From: [REDACTED] [REDACTED]
Sent: 20 November 2020 09:59
To: [REDACTED]
Subject: RE: Noise & Vibration comments 4309/19 Development Site At Tesco Extra 822 High Road, High Road, Chadwell Heath, Romford

Demolition of all existing buildings including petrol filling station. Redevelopment of the site to provide a replacement food retail store (use class A1, now superseded by use class E), a series of apartment blocks ranging between 4 and 23 storeys in height to provide 1,280 residential units (use class C3), flexible use floorspace for commercial/community uses (within use classes A1/A2/A3/B1/D1, all now superseded by use classes F1, F.2 and E), a 3-form entry primary school (use class D1, now superseded by use class F.1), public open space, car and cycle parking, associated landscaping and infrastructure works, and provision of pedestrian and vehicular access. (Summary). This application is accompanied by an Environmental Statement. (Amended plans and documents.)

Figure 10 - Developer NO₂ predictions for 2026 (With Development) scenario. Values shown are in $\mu\text{g}/\text{m}^3$.

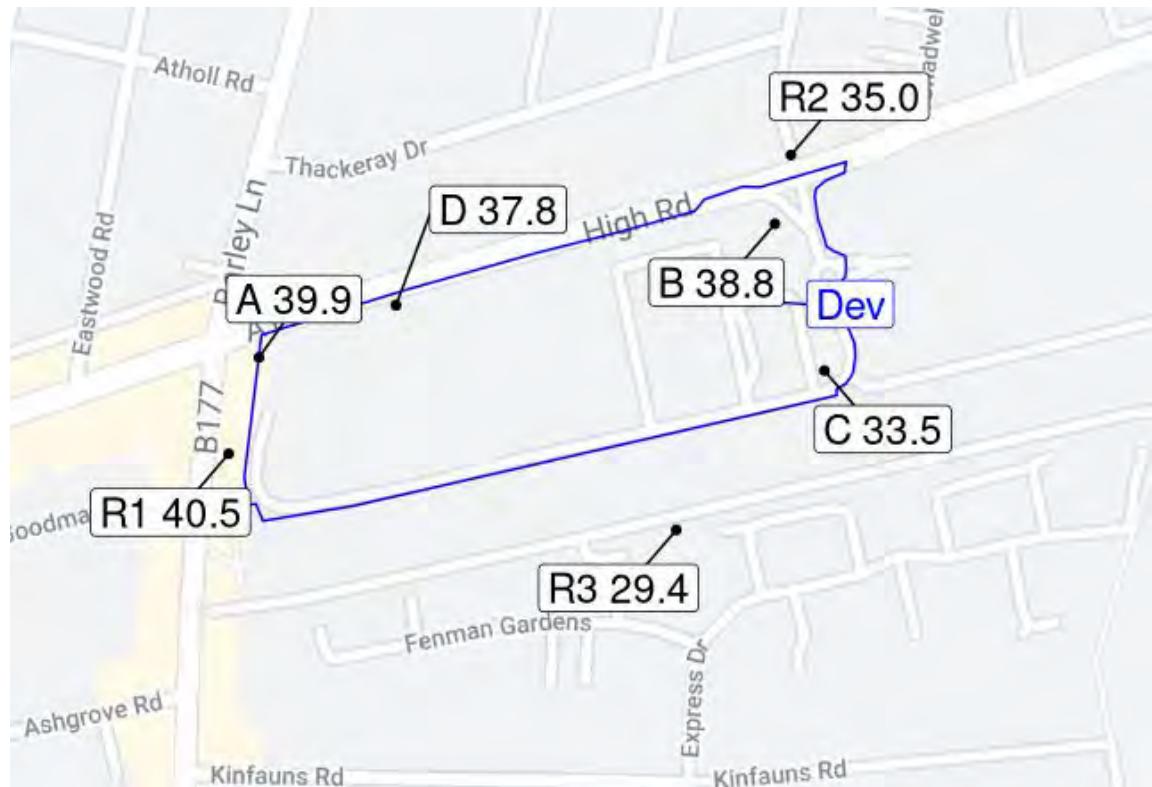
87. From Figure 10, which shows the developer's modeling for the with-development scenario, location R1 has a mean of 40.5 $\mu\text{g}/\text{m}^3$, and location A is at 39.9 $\mu\text{g}/\text{m}^3$, furthermore two other locations (B and D) are within 10% of the objective limit. So the levels are not only not "well below the annual mean level" but in one case exceed it.

Figure 13 - Locations and annualised results from diffusion tube monitoring by Aether for 6 months in 2019 / early 2020. Values shown are in $\mu\text{g}/\text{m}^3$.

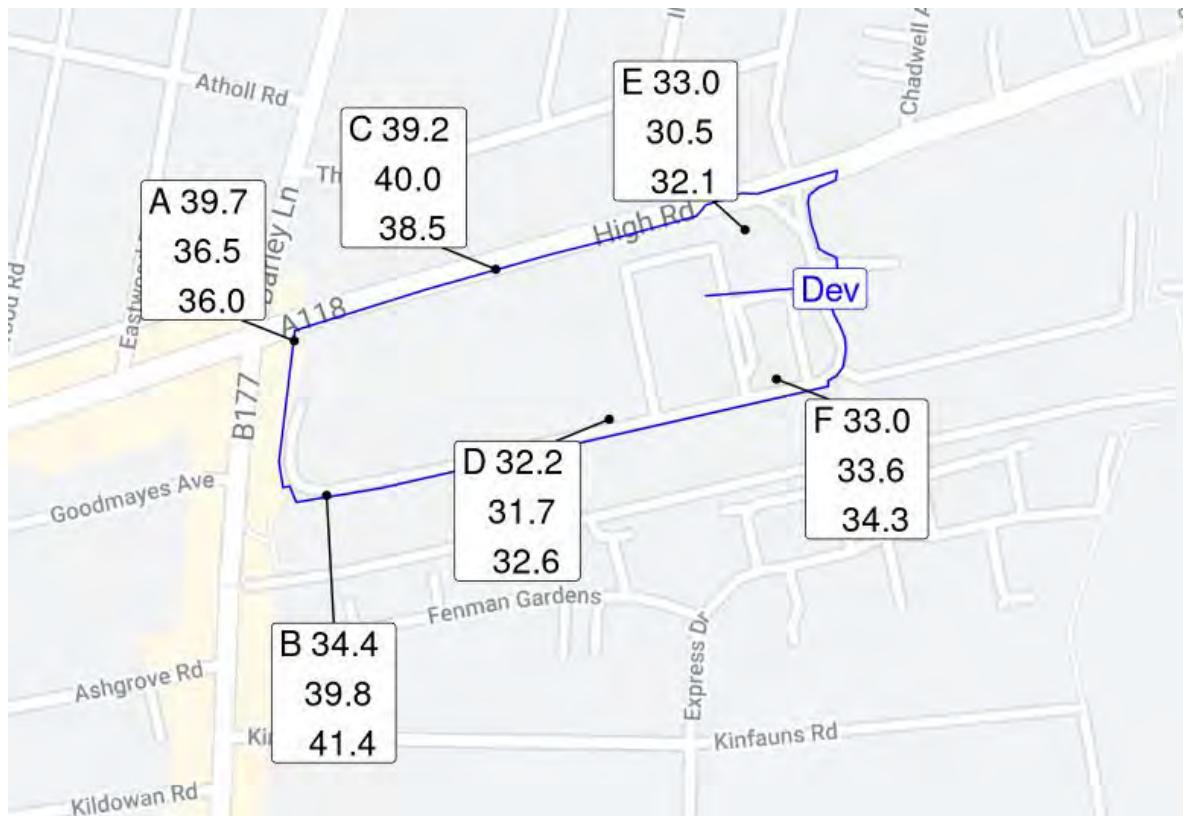
57. The results (as presented in Figure 10 of this document) do however show two diffusion tube sites (B and C) with single tubes of the triplicate showing exceedances. All three tubes at site A are within 10% of the objective limit.
58. Caution should be applied here as it may be that there are already breaches of the objective limit at the development site, given the high values seen combined with the inherent uncertainty of diffusion tubes.

88. This is backed up by the developer's air quality survey, whose results are shown in Figure 13, show that one of the tubes at the triplicated site show values above 40 $\mu\text{g}/\text{m}^3$, and some of the tubes at sites B and C are within 10% of the objective limit. Again not only not "well below the annual mean level" but in one case in excess of it.

Figure 14 - Monitoring location A is shielded from the road in a recessed location.

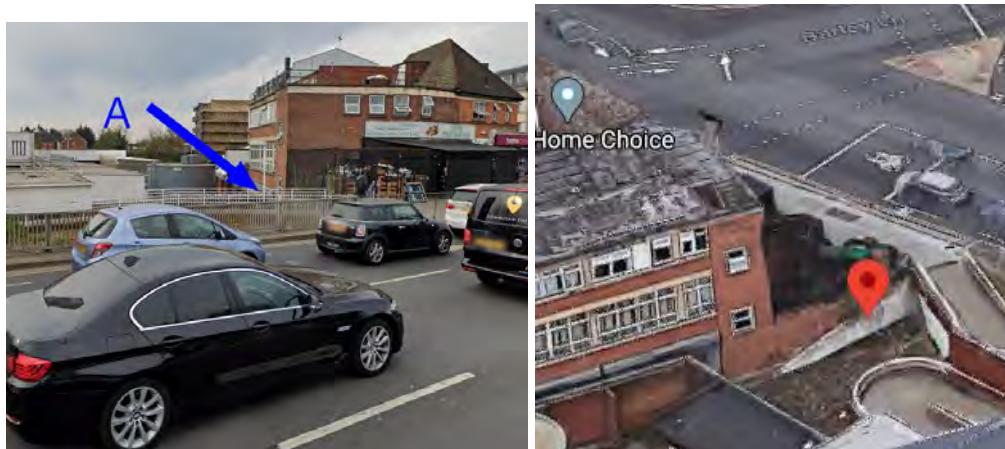
50. Figure 14 shows a picture of monitoring location A to illustrate that it is in a recessed location relative to the road and yet still shows very high values.

80. It is particularly important to establish the truth of this matter, because we learned from looking at the developer's diffusion tube measurements that even in the sunken location A (see Figure 14 of this document), that one tube returned a value of $39.7 \mu\text{g}/\text{m}^3$. One of the location C tubes on the High road measured $40.0 \mu\text{g}/\text{m}^3$.

Figure 15 - Illustration of gradients. ADMS-Roads complex terrain module is designed for no more than 1:3 and no less than 1:10.

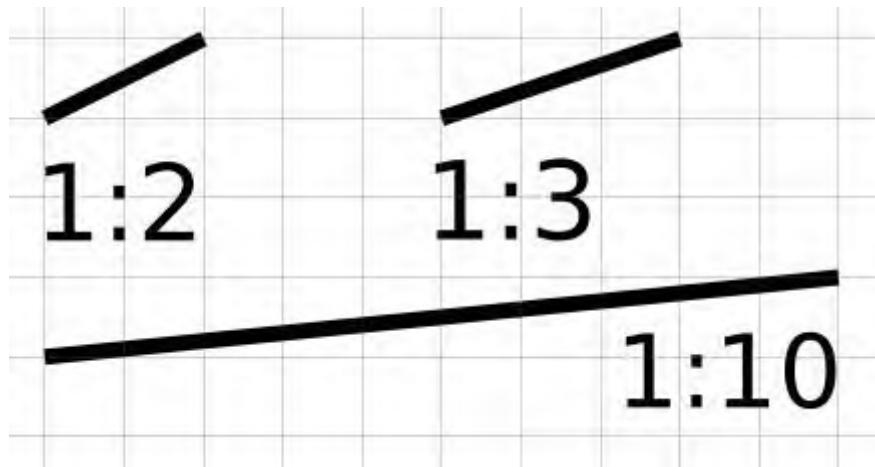
73. We have illustrated these gradients in Figure 15 for clarity.
